Pre-Drilling Plan Addendum Response to Email Comments Proposed South Water Supply Well, Bally Groundwater Contamination Superfund Site, Bally Borough, Berks County, Pennsylvania

11 August 2004

ARCADIS is writing in response to the comments contained in an email received from Mitch Cron of the USEPA sent on August 5, 2004 regarding the Pre-Drilling Plan Addendum (PDPA) for the aquifer test at the south site. The numbered comments from the USEPA email are included below in italics with ARCADIS's response following in standard text. An additional email comment received on August 10, 2004 from Greg Unger of Systems Design Engineering, Inc. (SDE) is listed as comment A.

## **Proposed Well Construction Diagram**

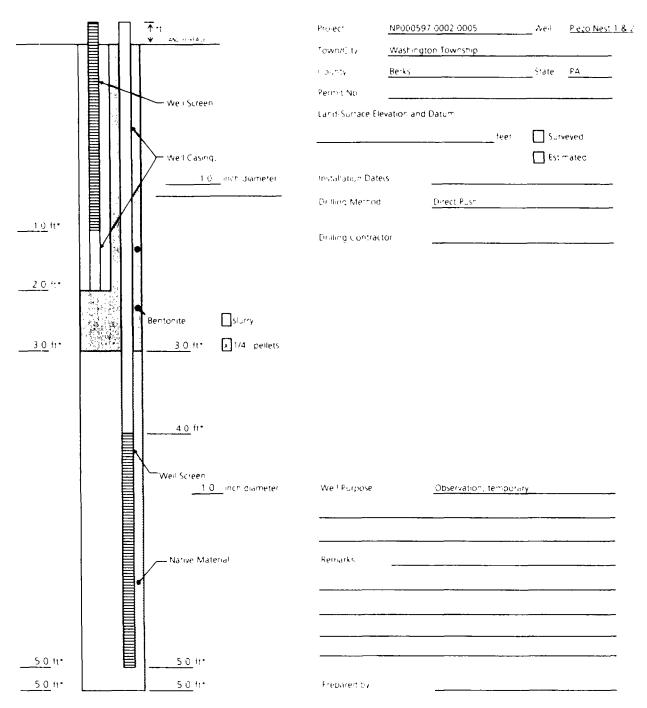
1. Please specify in the addendum the size and hydration time of the "bentonite pellets", referenced on Figure #2.

The size of the bentonite pellets referenced on Figure #2 (attached with slight revisions for clarification) will be 1/4 inch. Hydration time will not be limited since the piezometer clusters are expected to be placed in saturated soils with their location near or in the stream. However, a sufficient amount of potable water will be added, if necessary to fully hydrate.
